Access Audit Site Report

Cleburne State Park

Accessibility Evaluation

Inspection Date: 07/14/2021

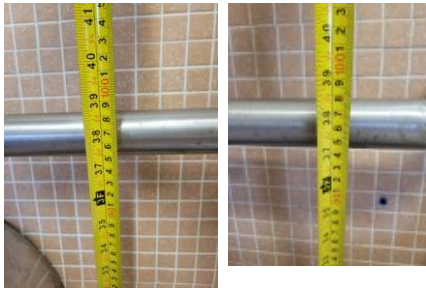
Finding Number	Area Description	Lat/Long	Finding	As Built	Recommendation	Citation	Photos	Figure
5	Headquarters Area: Maintenance	[32.25672, -97.54659]	The building entrance is not located on an accessible route. When a building, or portion of a building, is required to be accessible, an accessible route of travel shall be provided to all portions of the building, to accessible building entrances and between the building and the public way.	no AR to tractor garage, weed eating shed, trailer car port, gas station (elevated), gated stone building area, storage sheds (2 buildings, step up),	Create AR with crushed and compacted stone or similar outdoor material from parking or sidewalk to building entrance	2015 ABAAS Section: F206.2.1 2012 TAS Section: 206.2.1 2010 ADAS Section: 206.2.1		
6	Headquarters Area: Maintenance	[32.2555, -97.54808]	Spaces and elements within employee work areas shall only be required to comply with 206.2.8, 207.1, and 215.3 and shall be designed and constructed so that individuals with disabilities can approach, enter, and exit the employee work area. Employee work areas, or portions of employee work areas, other than raised courtroom stations, that are less than 300 square feet (28 m2) and elevated 7 inches (180 mm) or more above the finish floor or ground where the elevation is essential to the function of the space shall not be required to comply with these requirements or to be on an accessible route.	office- desk pull side MC, 27" wide, knob; shop door ok	For employee spaces, relocate storage, furniture, and other obstacles at doorways to provide approach, enter and exit at the employee space.	2015 ABAAS Section: F203.9 2012 TAS Section: 203.9 2010 ADAS Section: 203.9

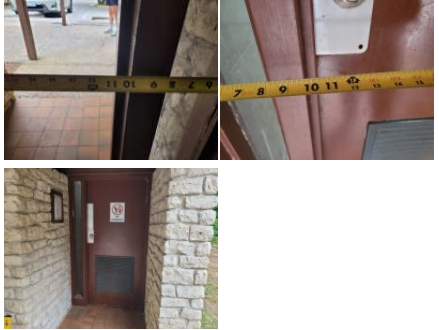
Finding Number	Area Description	Lat/Long	Finding	As Built	Recommendation	Citation	Photos	Figure
40	Headquarters Area: Restrooms Exterior Accessible Route	[32.2555607 , -97.552421 9]	The walkway contains abrupt vertical edges and/or variations over a 1/4 inch. 1/4 inch is the maximum vertical rise. Changes in level between 1/4 inch and 1/2 inch must be beveled at 1:2 or less. Changes in level greater than 1/2 inch must be by way of a ramp.	1.5" change in level (CIL) on sidewalk outside of women's restroom, CIL to trash cans, 1" CIL up to building platform	Repair, bevel or ramp CIL along AR	2012 TAS Section: 303.2, 303.3 2010 ADAS Section: 303.2, 303.3		
41	Headquarters Area: Restrooms Exterior Accessible Route	[32.2555156 , -97.552477 4]	The hammer for emergency fire extinguisher is positioned too high for either a side or front approach. Where a clear floor or ground space allows a parallel approach to an element and the side reach is unobstructed, the high side reach shall be 48 inches maximum and the low side reach shall be 15 inches minimum above the finish floor or ground. Where a forward reach is unobstructed, the high forward reach shall be 48 inches maximum and the low forward reach shall be 15 inches minimum above the finish floor or ground.	height for hammer at 61" aff	Remount operable parts to be in reach range of 15" min to 48" max	2015 ABAAS Section: 308.1 2012 TAS Section: 308.1 2010 ADAS Section: 308.1

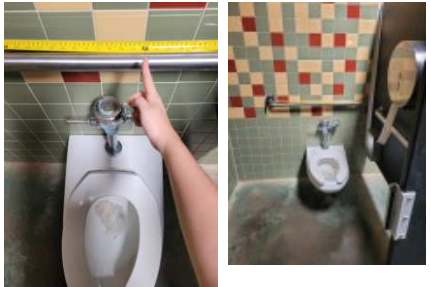
Finding Number	Area Description	Lat/Long	Finding	As Built	Recommendation	Citation	Photos	Figure
112	Cedar Lodge Area: Cedar Lodge Interior	[32.26989, -97.56271]	Knee and toe space has not been provided at the sink. Kitchen sinks must be provided with a clear floor space positioned for a forward approach including knee and toe clearance.	24" knee clearance height for island sinks, 22.5" height sinks along wall, 6" depth on back sink	See previous finding for cost Raise sink bowl to provide 27" knee clearance, in the alternative, acquire a shallower model	2015 ABAAS Section: 606.2, 804.4 2012 TAS Section: 606.2, 804.4 2010 ADAS Section: 606.2, 804.4

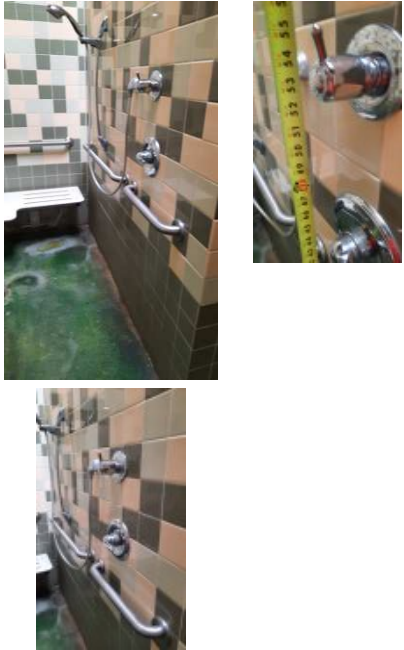
Finding Number	Area Description	Lat/Long	Finding	As Built	Recommendation	Citation	Photos	Figure
167	Camping Areas: Men's Barracks Restroom	[32.25672, -97.54659]	The stall door fails to comply with all of the door requirements. The stall door must be a minimum of 32" wide and have compliant hardware on both sides. The stall door must be self-closing.	not self closing	Adjust stall door to be self-closing	2015 ABAAS Section: 404.2.3, 404.2.7, 604.8.2.2 2012 TAS Section: 404.2.3, 404.2.7, 604.8.2.2 2010 ADAS Section: 404.2.3, 404.2.7, 604.8.2.2		
168	Camping Areas: Men's Barracks Restroom	[32.25672, -97.54659]	The toilet paper is not installed within the compliant range in front of the toilet. Toilet paper dispensers shall be 7 inches minimum and 9 inches maximum in front of the water closet measured to the centerline of the dispenser. The outlet of the dispenser shall be 15 inches minimum and 48 inches maximum above the finish floor and shall not be located behind grab bars. Dispensers shall not be of a type that controls delivery or that does not allow continuous paper flow. There shall be a clearance of 1 1/2 inches minimum below the grab bar.	toilet paper too close to the front of the toilet	Remount toilet paper dispenser max 7" to 9" from front of toilet, 15" to 48" aff and min 12" above or 1.5" below grab bar	2015 ABAAS Section: 604.7 2012 TAS Section: 604.7 2010 ADAS Section: 604.7

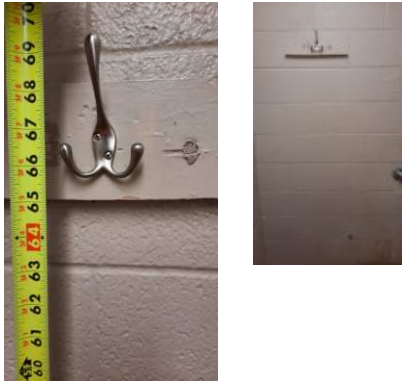
Finding Number	Area Description	Lat/Long	Finding	As Built	Recommendation	Citation	Photos	Figure
199	Camping Areas: North Creek Campsites Area	[32.2731577 , -97.563937 2]	There are no van accessible parking stalls. 1 in every 6, minimum of one, required accessible stalls must be a van accessible stall. There are a total of 4 parking stalls in the parking lot that could be reasonably associated with this facility. There should be a minimum of 1 accessible stalls with a minimum of 1 being designed as van accessible.	restroom building - lacks dimension for van stall	Add van parking sign to 1 accessible stall and repaint stall and access aisle to 11' and 5' or 8' and 8' per the table	2015 ABAAS Section: F208.2, F208.2.4 2012 TAS Section: 208.2, 208.2.4 2010 ADAS Section: 208.2, 208.2.4		
200	Camping Areas: North Creek Campsites Area	[32.2731361 , -97.563951 9]	The cross slopes (narrow dimension) and/or running slopes (long dimension) of the access aisle exceeds 2%. The running slope and the cross slope in an accessible parking stall and the access aisle must not exceed 2%.	restroom building - 3.3% running slope	Repair or correct slope of parking space and access aisle to max 2.08% in any direction	2015 ABAAS Section: 502.4 2012 TAS Section: 502.4 2010 ADAS Section: 502.4

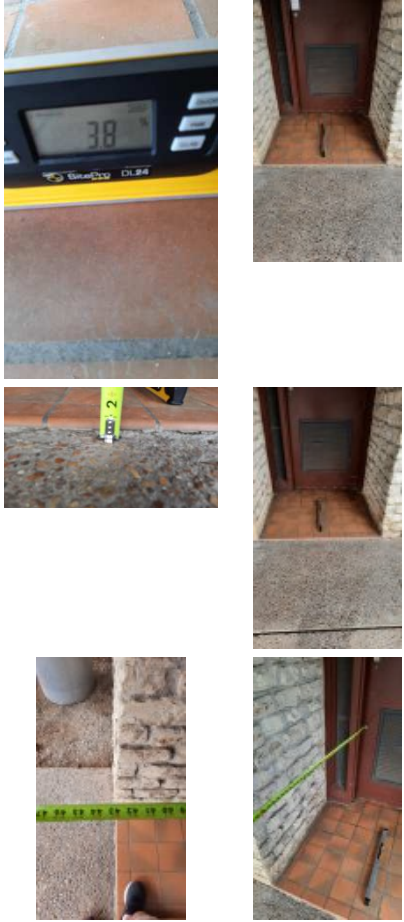
Finding Number	Area Description	Lat/Long	Finding	As Built	Recommendation	Citation	Photos	Figure
220	Camping Areas: North Creek Bath House	[32.25672, -97.54659]	The ambulatory stall is not between 35" to 37" wide and 60" deep.	Women's Restroom - 38" wide	Correct ambulatory stall to be 35" to 37" wide and minimum 60" deep	2015 ABAAS Section: 604.8.2.1 2012 TAS Section: 604.8.2.1 2010 ADAS Section: 604.8.2.1		
221	Camping Areas: North Creek Bath House	[32.25672, -97.54659]	The toilet is not located within the range to the side wall or partition. The centerline of the toilet shall be 17 inches minimum and 19 inches maximum side wall or partition in the ambulatory accessible toilet compartment.	Women's Restroom - 22.75" from wall	Remount toilet to 17" to 19" from the side wall to center line in ambulatory stalls	2015 ABAAS Section: 604.9.1 2012 TAS Section: 604.9.1 2010 ADAS Section: 604.9.1
